# PBB model enhancements

Supporting 802.1ah comment 176, 178, 181, 182, 186, 188

Maarten Vissers

May 2007

# Delete duplicated functionality from C 6.10 ( $\Rightarrow$ C 6.10')

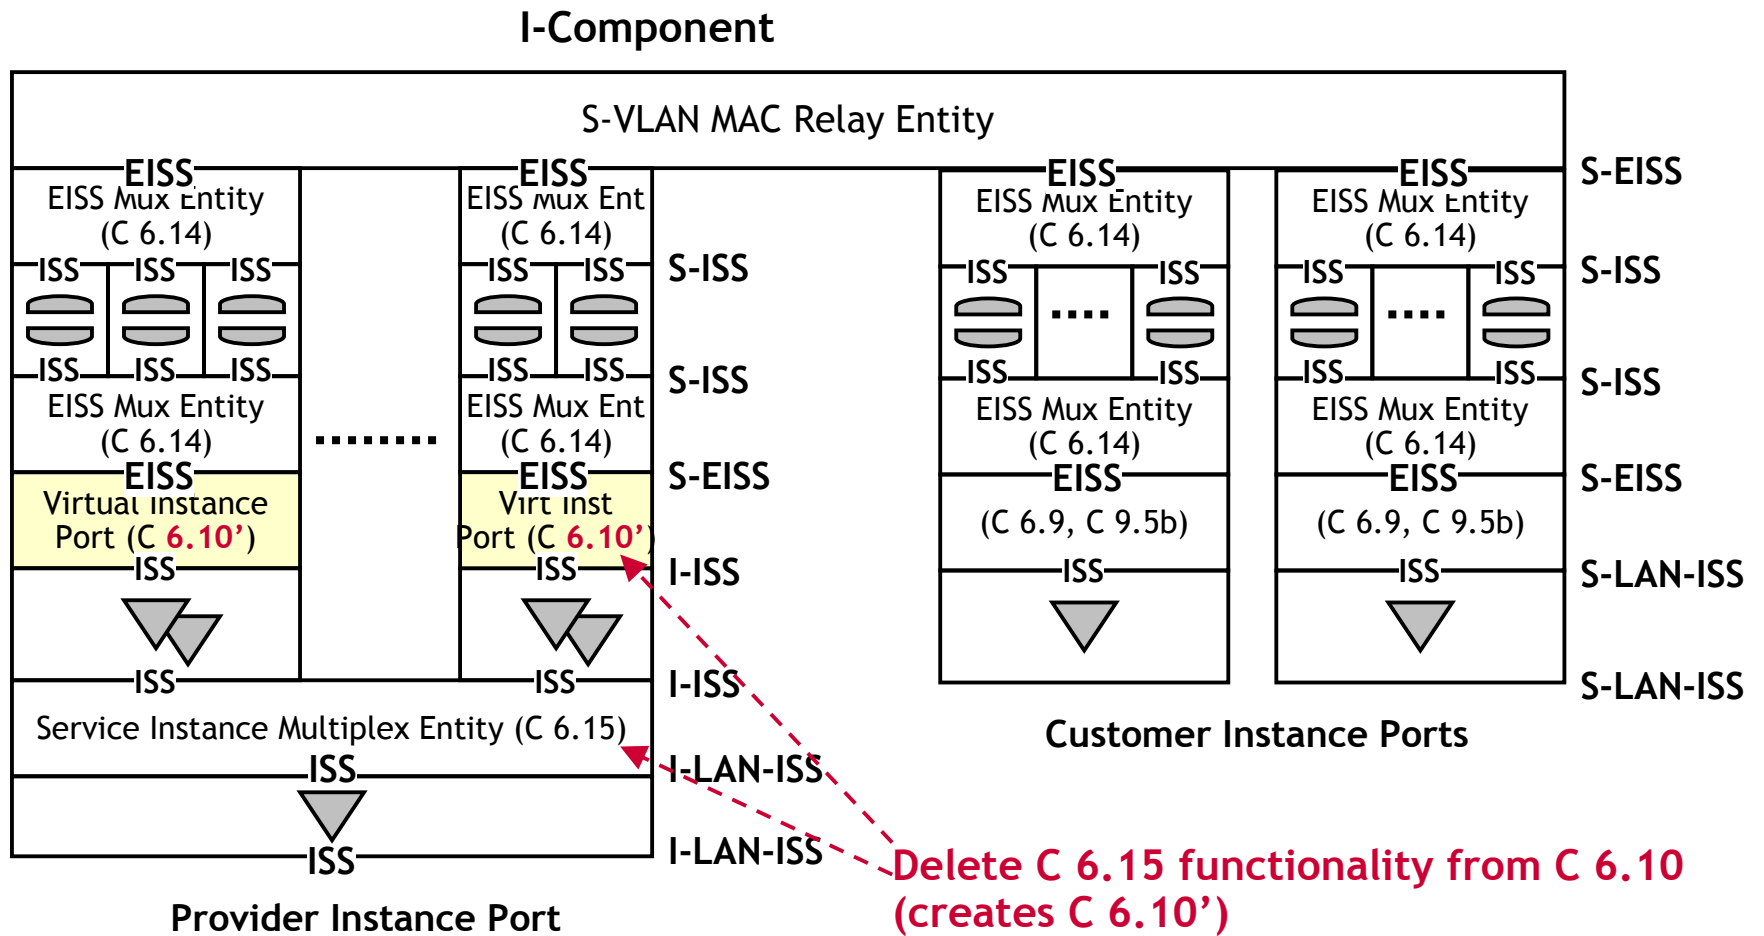
Clause 6.15 functionality included also in clause 6.10

- ❑ duplication unnecessary in case of single clause 6.10 instance per PIP
- ❑ duplication non functional in case of multiple clause 6.10 instances per PIP
- ❑ delete duplicate functionality from clause 6.10 (see slide 4)

# Separate C 6.9 functionality from MAC Encapsulation in C 6.10 (⇒ C 6.10'')

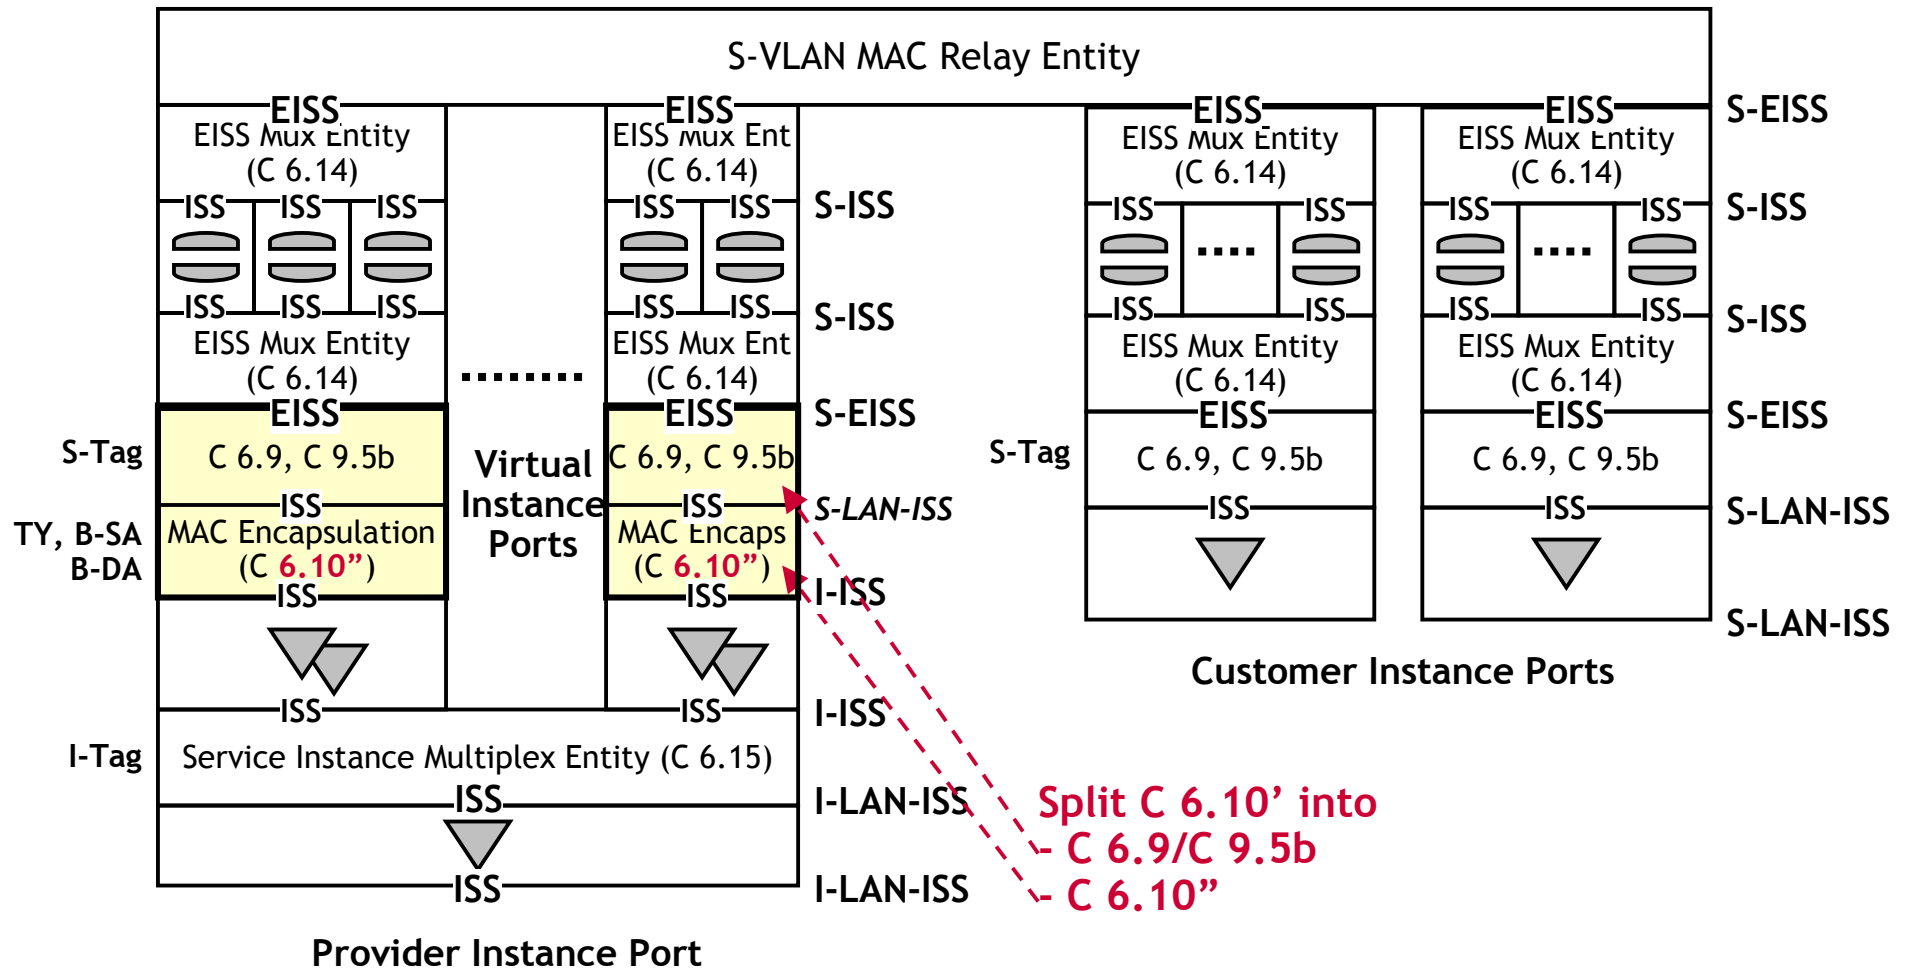
Clause 6.10 combines clause 6.9 functionality with MAC encapsulation

- ❑ duplication of specification unnecessary
- ❑ separate two independent functions (see slide 5)

# Support I-ISS by additional technologies (C 6.11/802.1ad) (comment #181, #182)

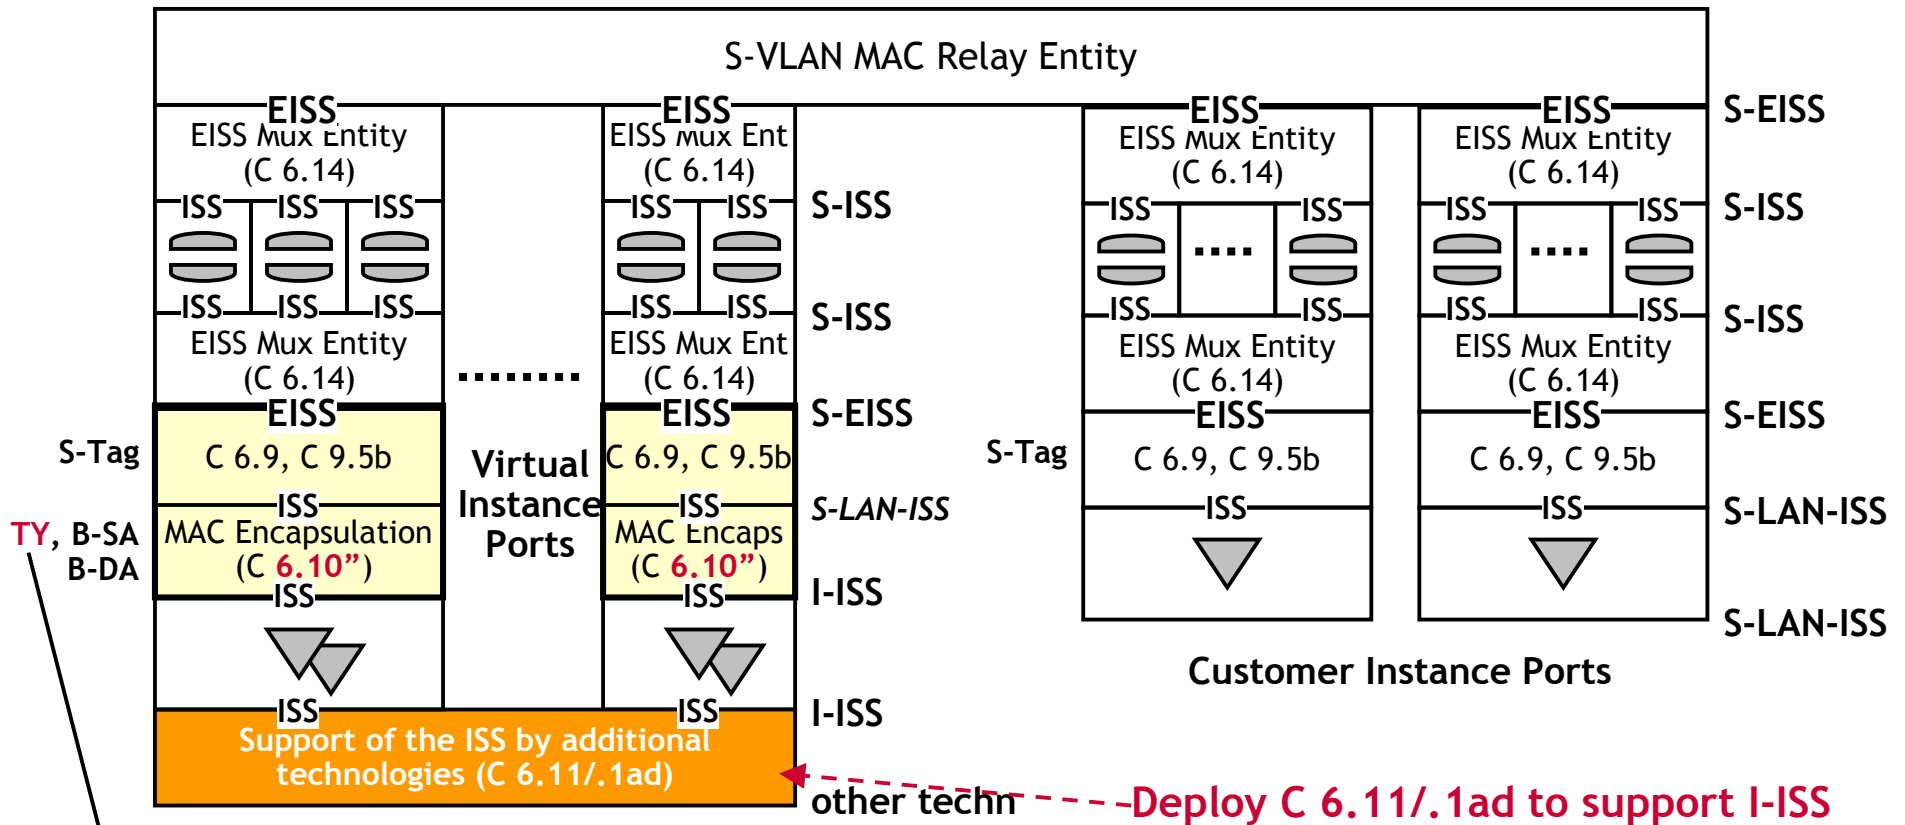
802.1ah/D3.5 ignores clause 6.11/.1ad

- ❑ enhancement necessary
- ❑ add support of clause 6.10 ISS by additional technologies (see slide 6)

**TYPE field is mandatory when ISS supported by additional technologies**

# Add B-VLAN Instances, delete duplicate functionality, depict Service Instance switch

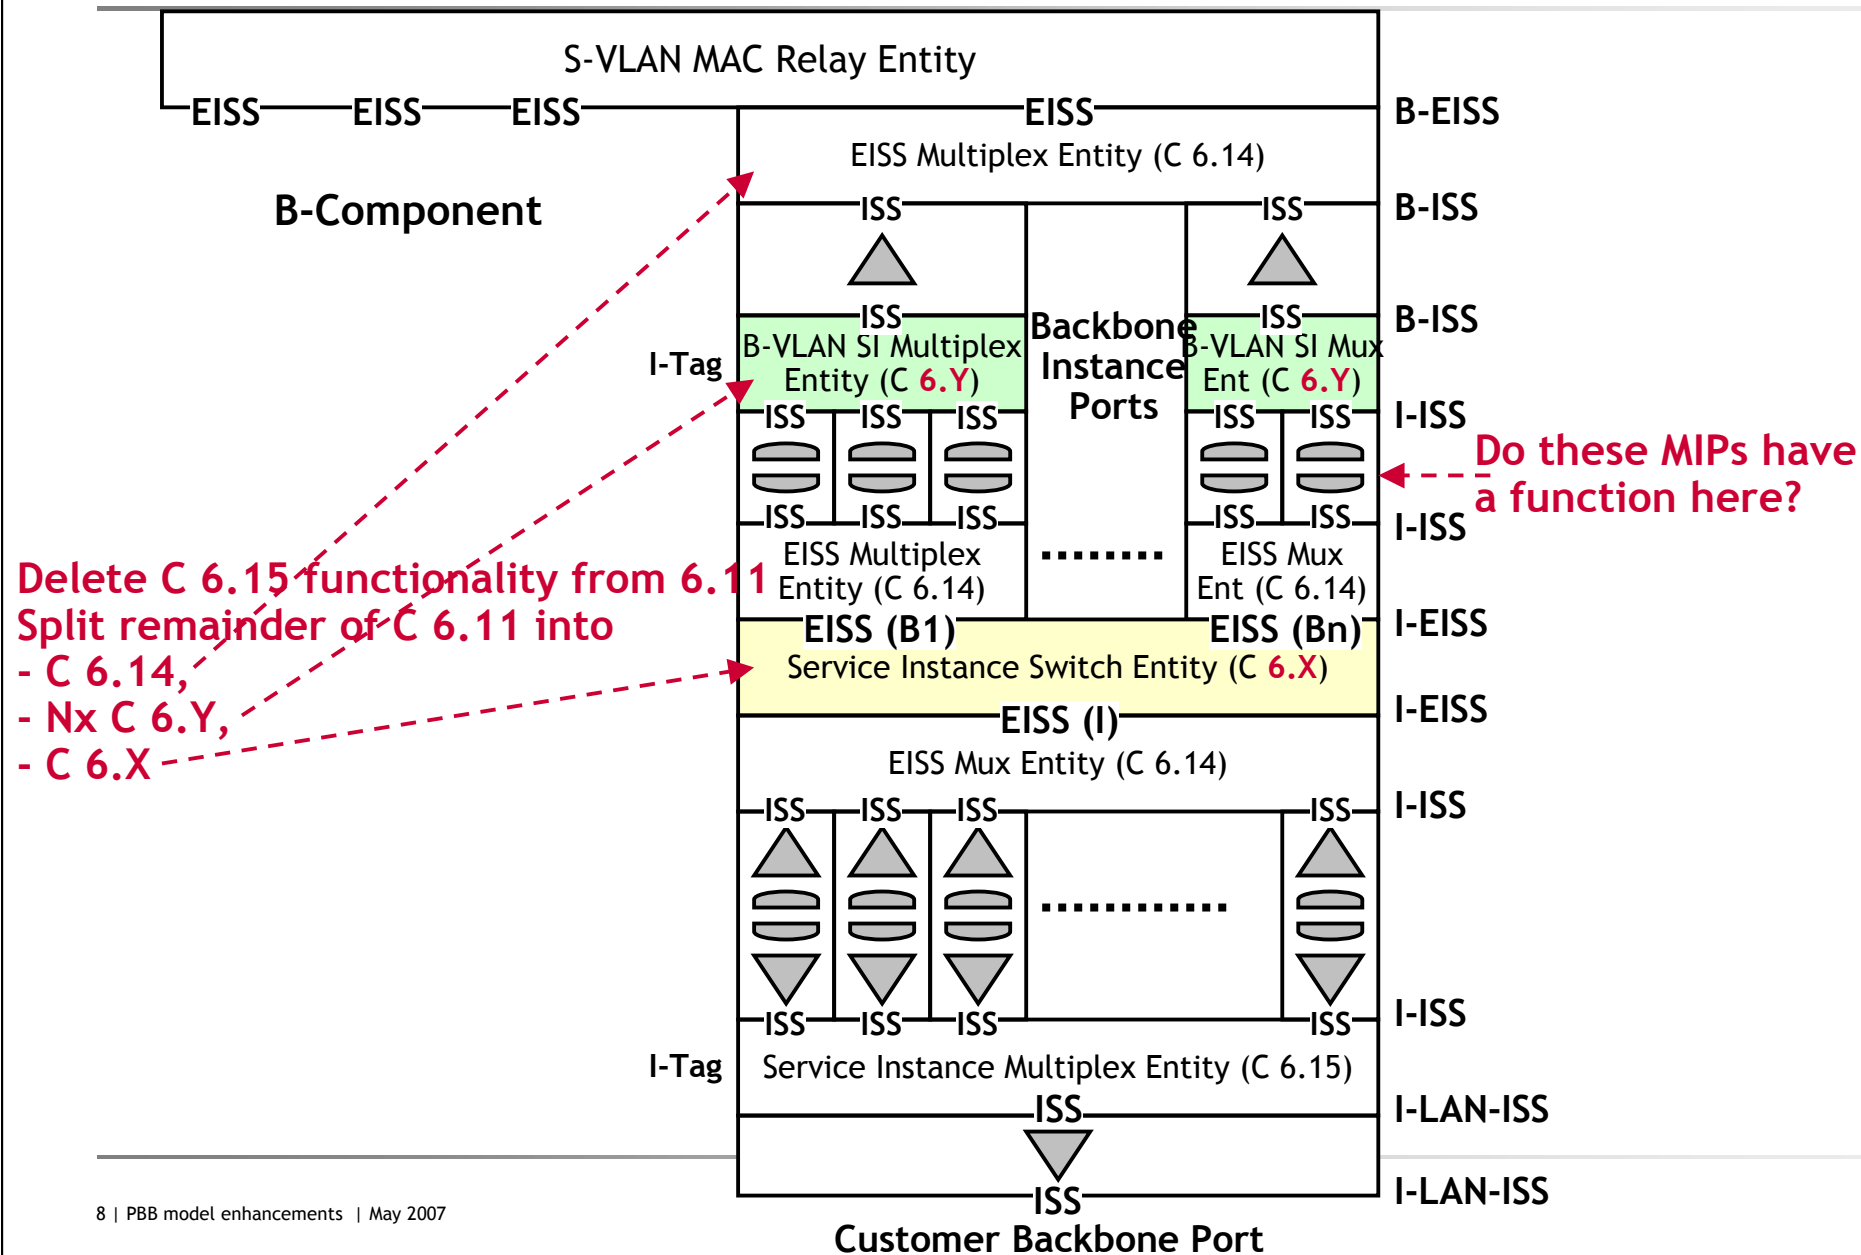
Clause 26.8/Figure 26-2 does not present B-VLAN instances

Clause 26.8/Figure 26-2 does not present B-VLAN MEPs

- enhancement necessary (see slide 8)

Clause 6.11 includes clause 6.15 Srvc Instance Mux Entity functionality

Clause 26.8/Figure 26-2 includes clause 6.11 and 2x clause 6.15

- in total three instances of clause 6.15 functionality specified in CBP
- one instance is sufficient
- enhancement appropriate (see slide 8)

Clause 6.11 includes PBB Service Instance switch functionality

- similar to C-VLAN Component MAC Relay functionality in clause 15.4/.1ad
- aggregates service instances into one or more B-VLAN instances
- consistency in 802.1Q specifications
  - describe PBB Service Instance switch function similar to C-VLAN Component MAC Relay function (see slide 8)

# Add MAC Encapsulation to Backbone VLAN (Comment #188)

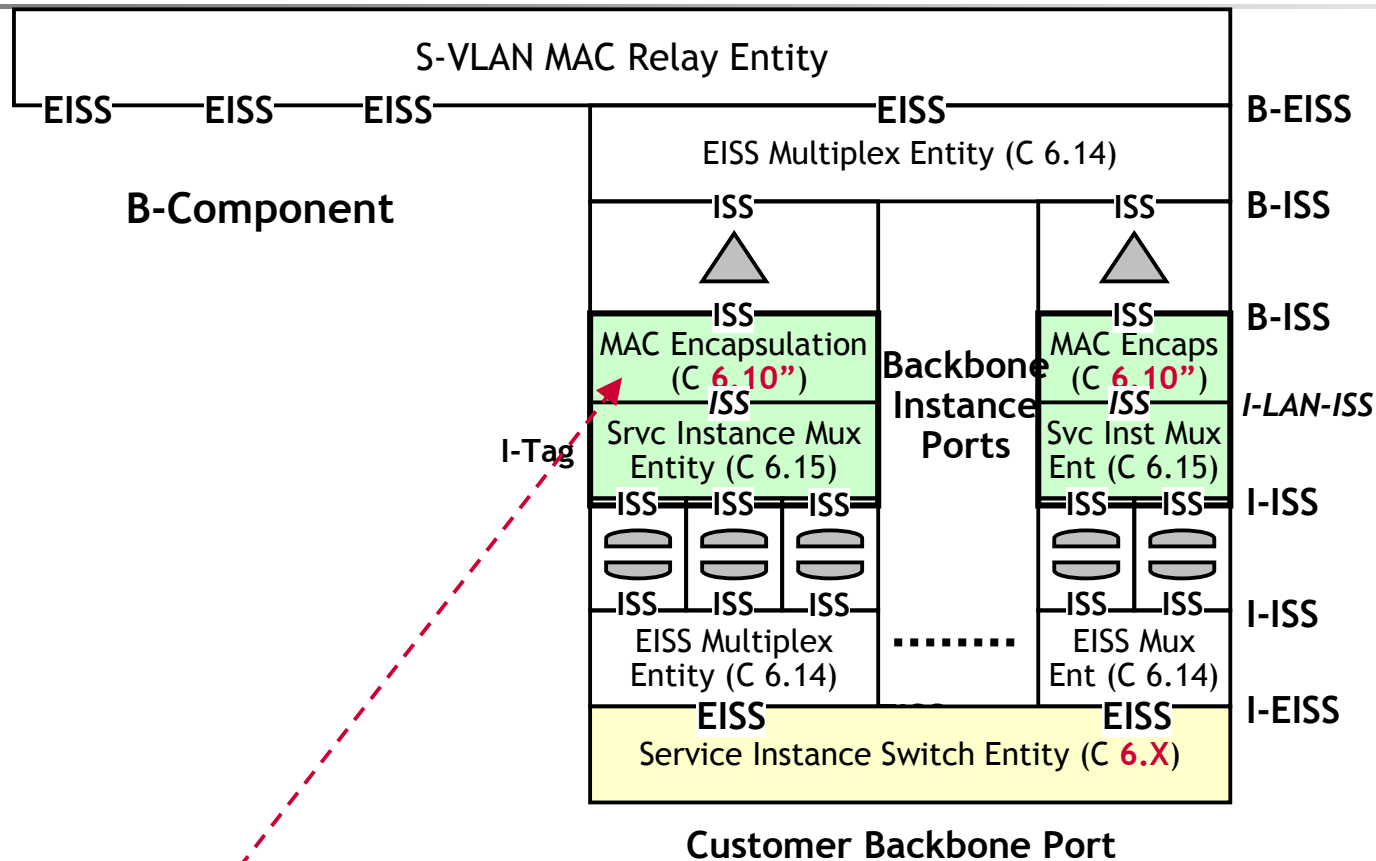
- Additional MAC Encapsulation takes away Service Instance dependency with B-VLAN
- PBB SI can deploy all-group address; no need for <802.1ah.ISID> group MAC address in SI
- no need for MAC address Translation any longer; replaced by MAC encapsulation
- true “Backbone-MAC” address
- current B-MAC is a “Service-MAC” address
